SEWAGE DISPOSAL SYSTEM

DEPARTMENT OF HEALTH AND MENTAL HYGIENE

A REPAIR

SUBDIVISION _____ LOT _____ ROAD 9780 Old Annapolis Road

INDICATE NORTH - NAME ADJOINING ROADWAY AS BASE LINE

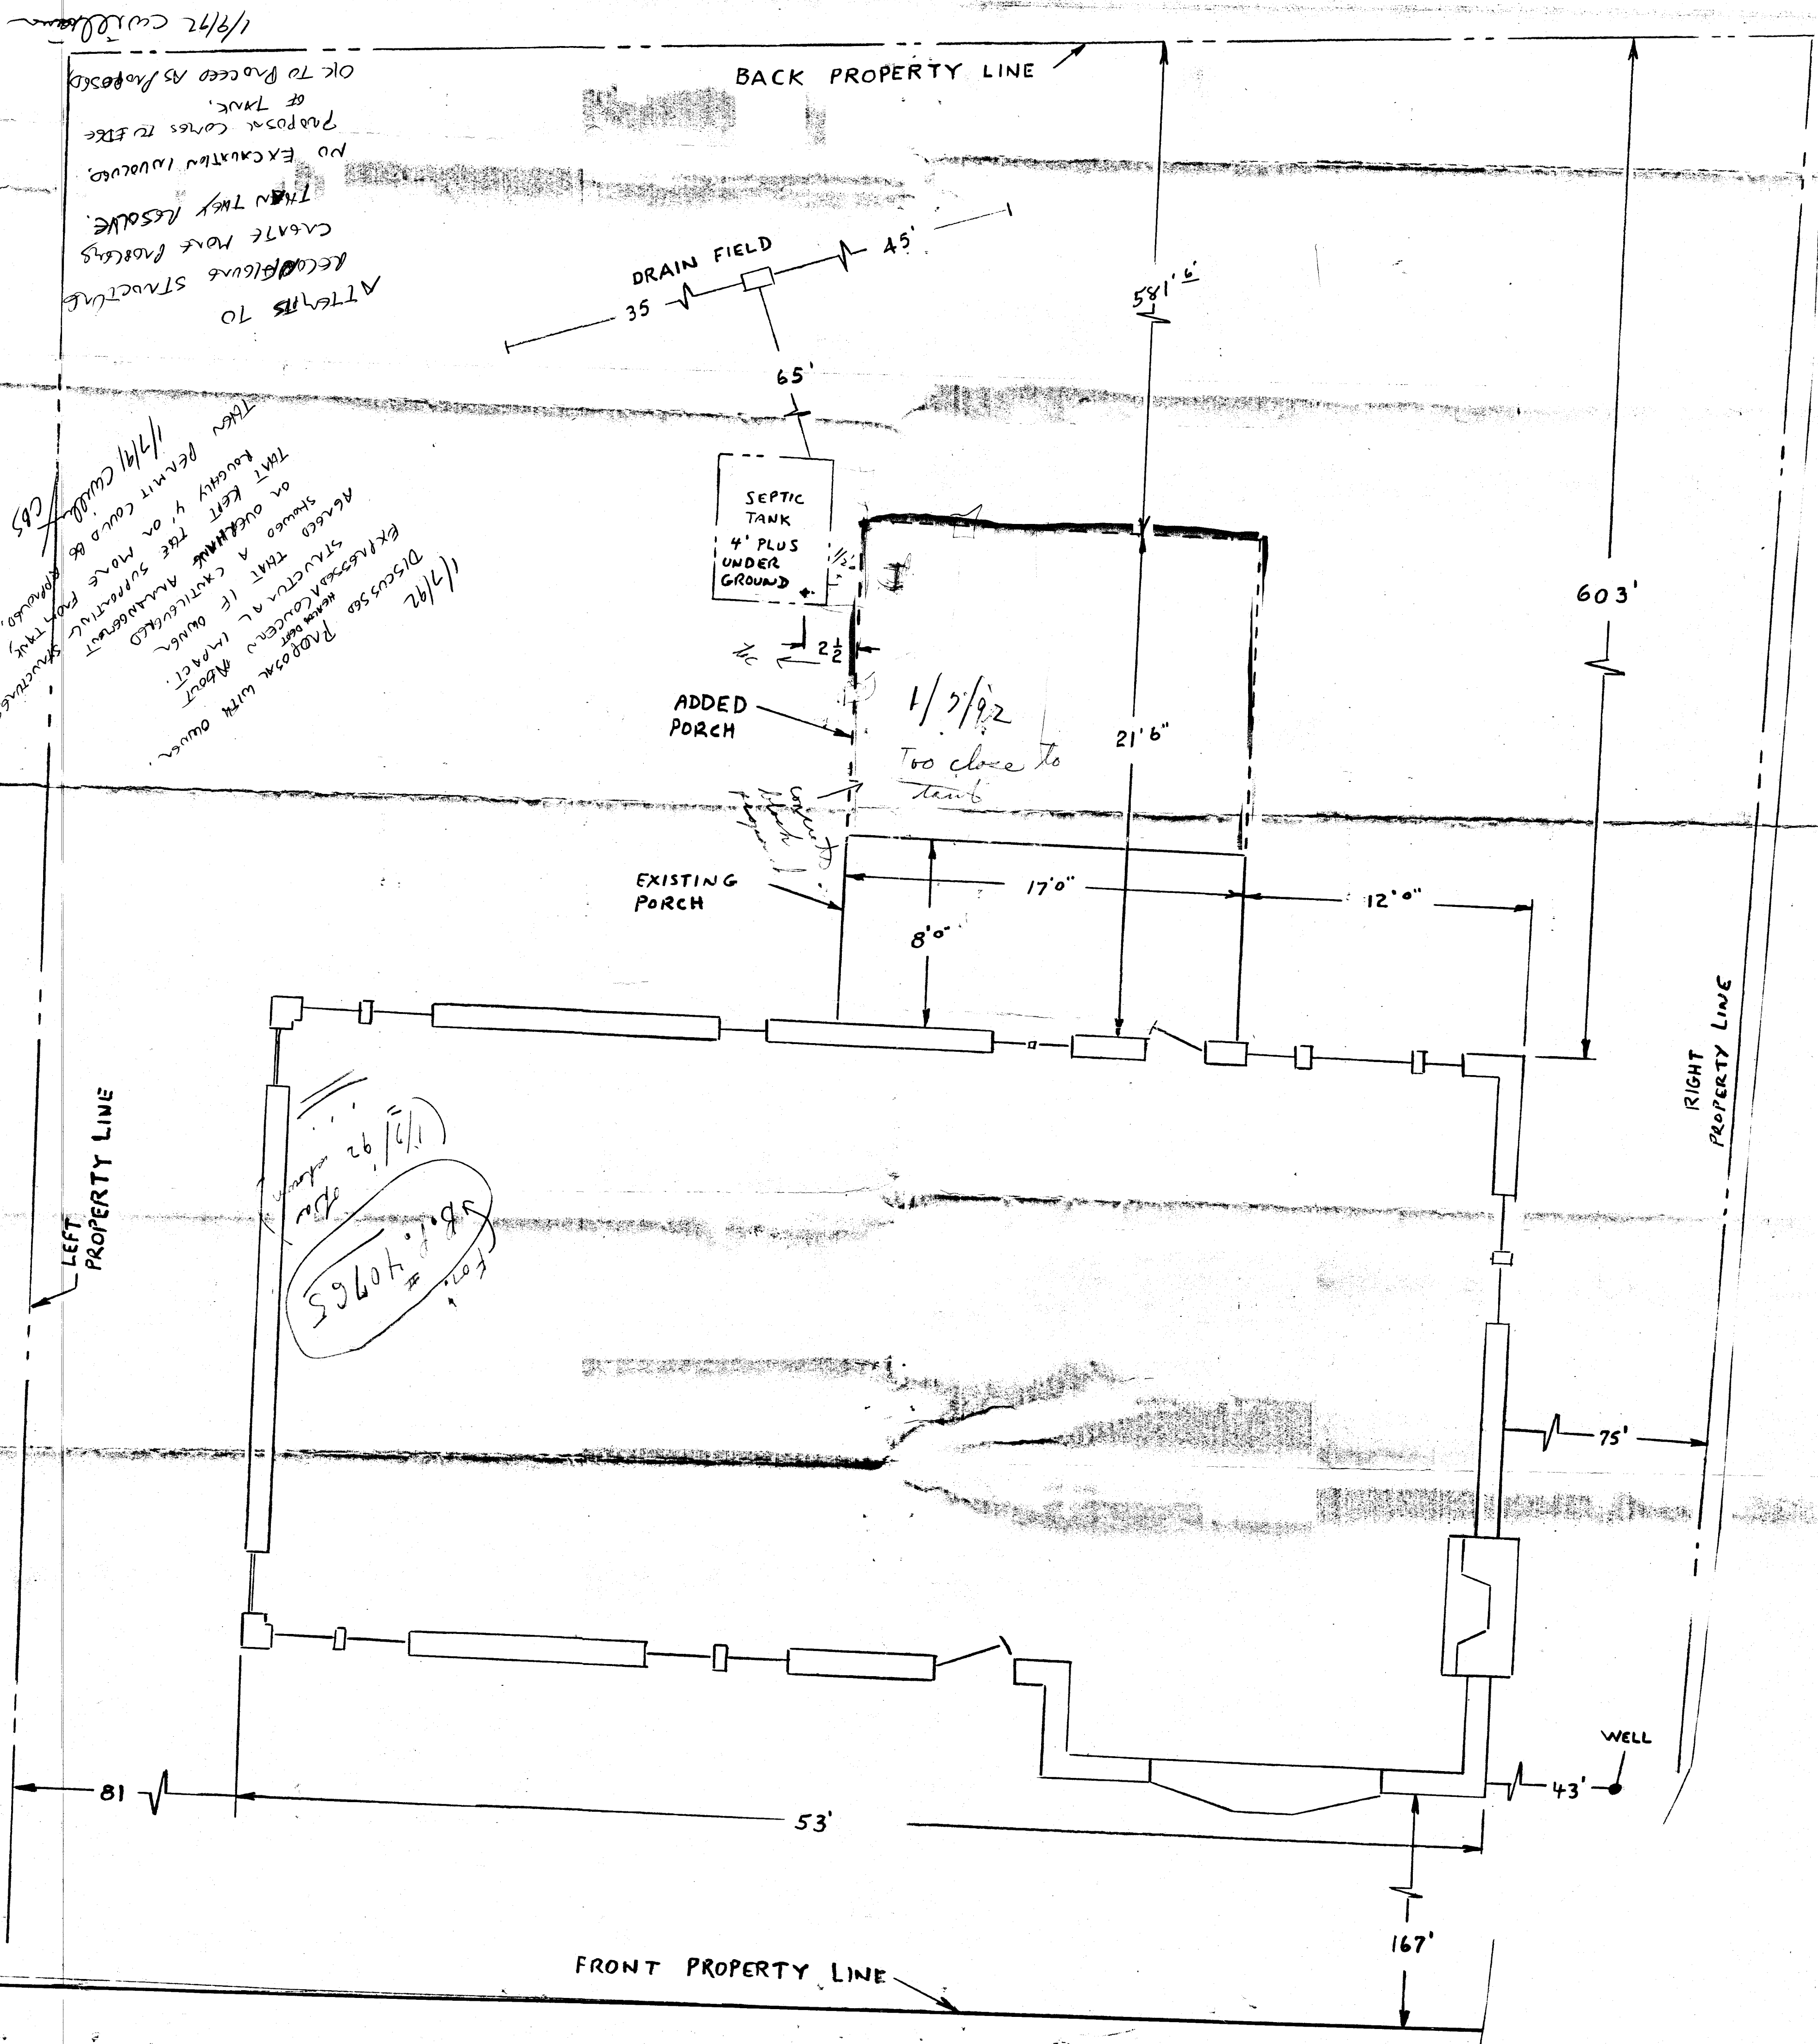
SEPTIC TANK LEVEL OK Existing Old Annapolis Road CLEANOUTS OK S.T.

DISTRIBUTION BOX LEVEL OK (Ballie is in)

DRAIN FIELD/TILE DEPTH ① 2 1/2' + ② 2' + TRENCH WIDTH 2 FT. INLET DEPTH 2 FT.

EFFECTIVE GRAVEL DEPTH 5' + TOTAL LENGTH ① 43' ② 32' = 75' FT.

NUMBER OF TRENCHES 2 ONE SIDEWALL/BOTTOM AREA 375 SQ. FT.

ABSORBENT AREA 375 SQ. FT.

REMARKS: P.M. 10/2/91 New septic tank not installed,
man line to be installed from septic tank to
new distribution box and to trenches; ok to put
stones in trenches and last 13' of ② trench; parted.
10/3 No inspection - bad weather, c.B.S. 10/7/91 A.M. Final ok to cover
all work.
